febiEXAKT

Water pump

febi no. 32682

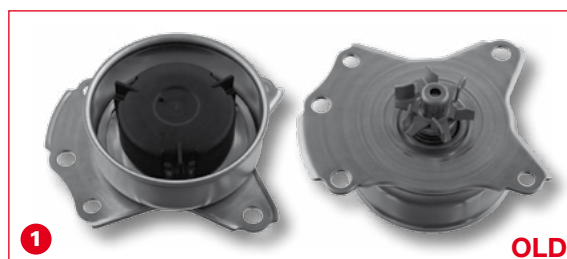
The water pump leaks.

The water pump fitted by the vehicle manufacturer can leak, because the material used is perforated steel sheet. In the worst case, this can lead to significant engine damage.

febi recommends using water pump febi no. 32682. This modified version of the water pump is manufactured from aluminium die casting. This makes the pump significantly stronger, and prevents leakage. Additionally, febi supplies water pump 32682 including the required gasket and suitable bolt set.

When fitting the new version febi 32682, please use bolts supplied with water pump. Torque setting for bolts is 28nM. The vehicle manufacturer's specifications should always be followed!
